IRON FENCE W/ BRICK COLUMNS

BRAYSTONE PARK
 BELLVERVILLE, TN.
 MILLARD & STEVENS, ARCHITECT

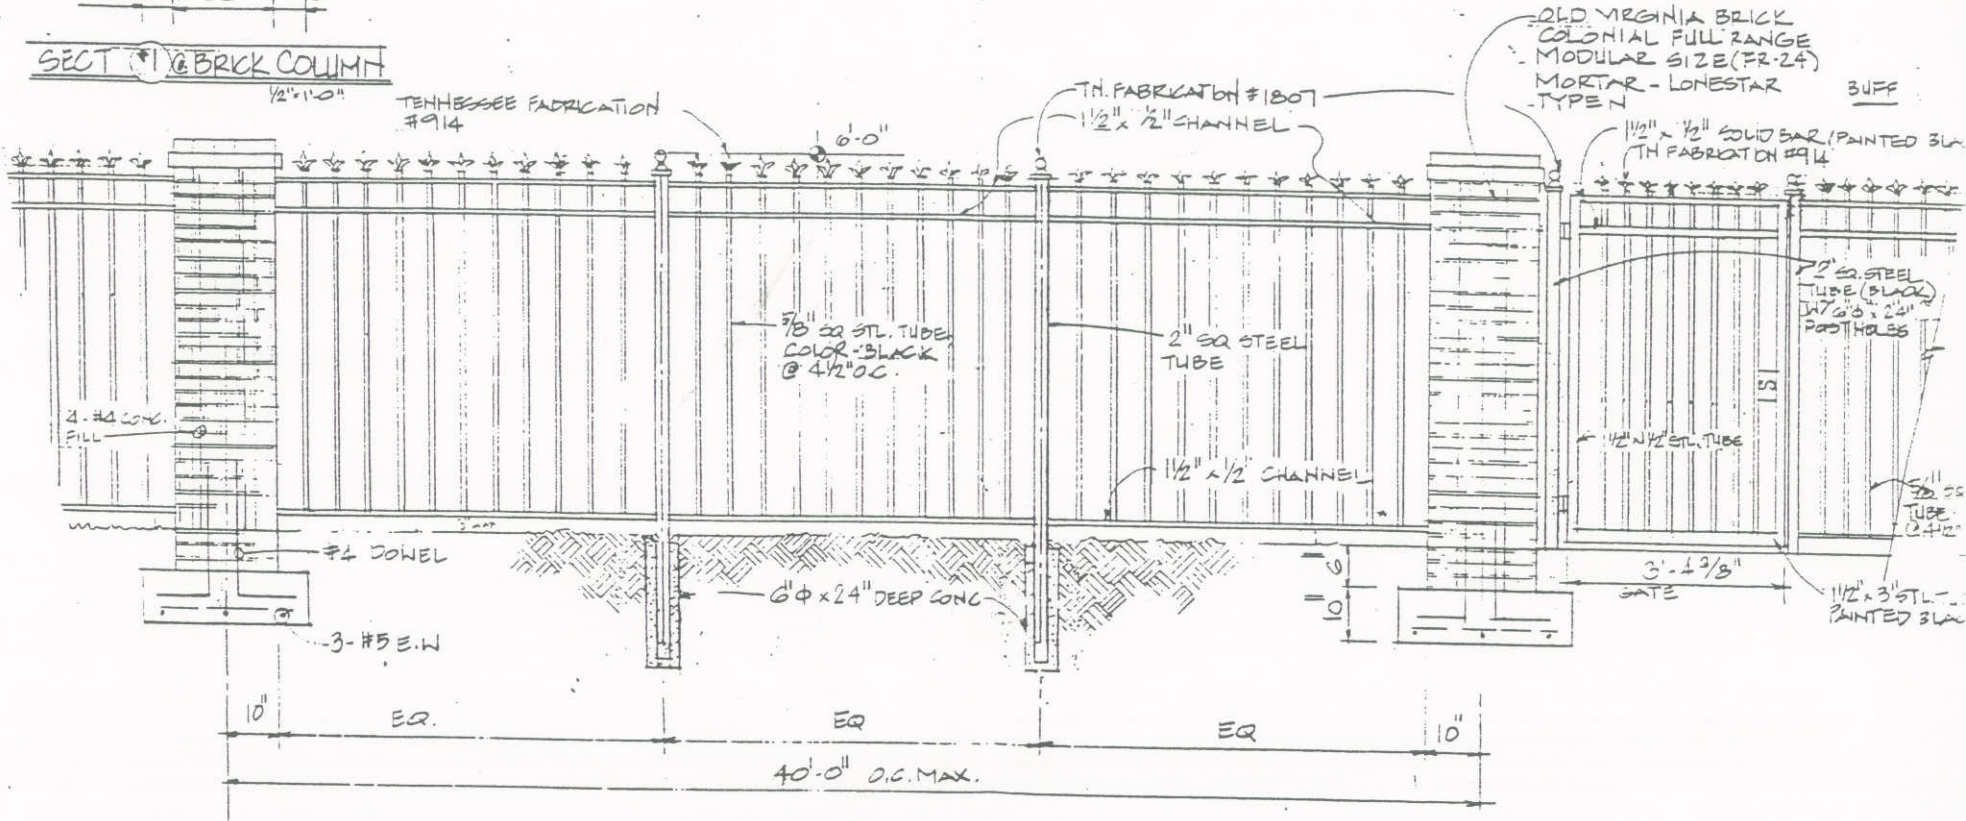
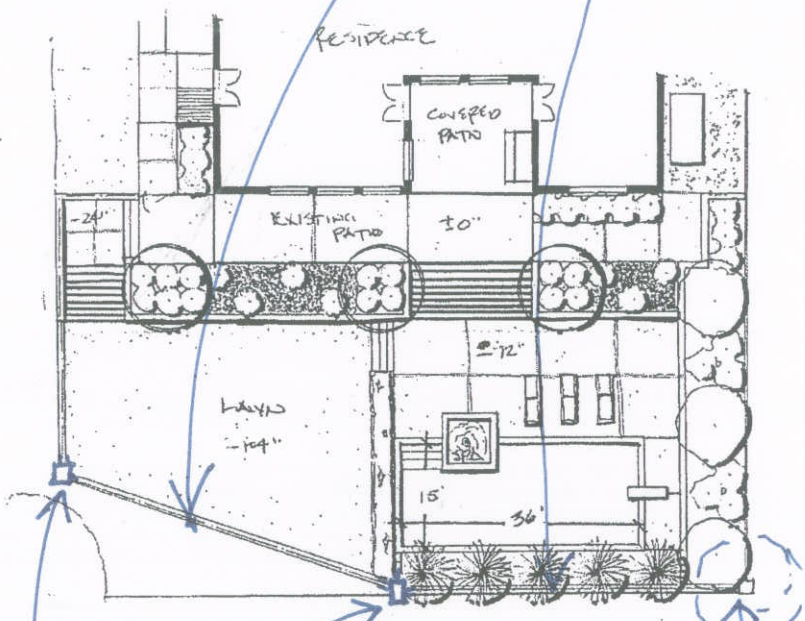
IF FENCING IS REQ'D
 BY CODE, ~~FENCE~~ ALONG
 THE COS AS IT MUST
 BE TO THE COMMUNITY
 SET STANDARD. WROUGHT
 IRON W/ BRICK COLUMNS.

ADD (TWO) MORE BRICK
 COLUMNS TO MATCH THIS
 EXISTING ONE.

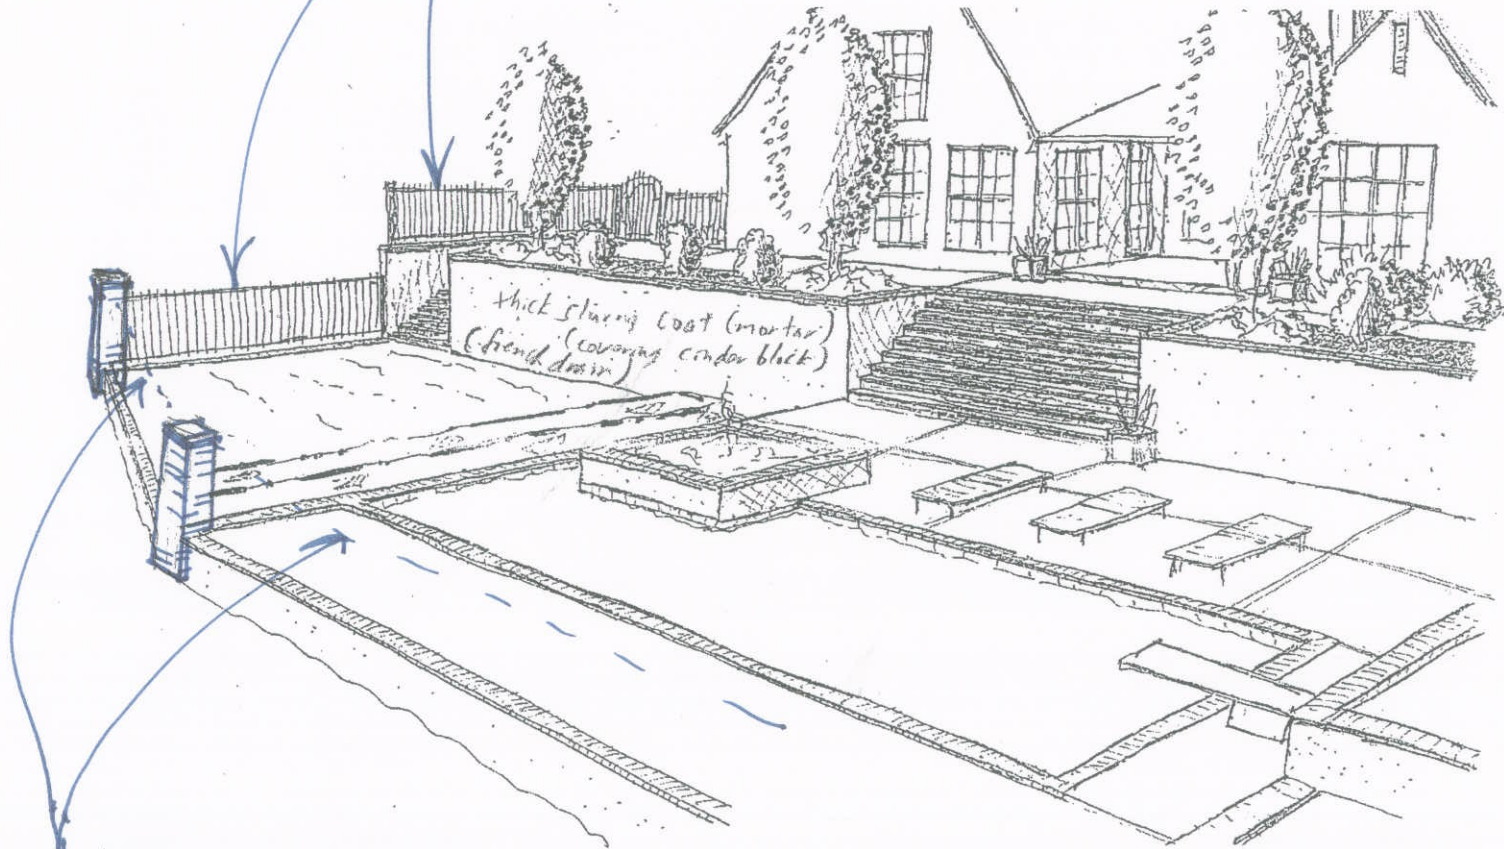
IS THIS IRON OR WOOD?
EITHER IS FINE.

FENCING HERE
MUST BE IRON PER
THE BRAYSTONE
STANDARD (ATTACHED)
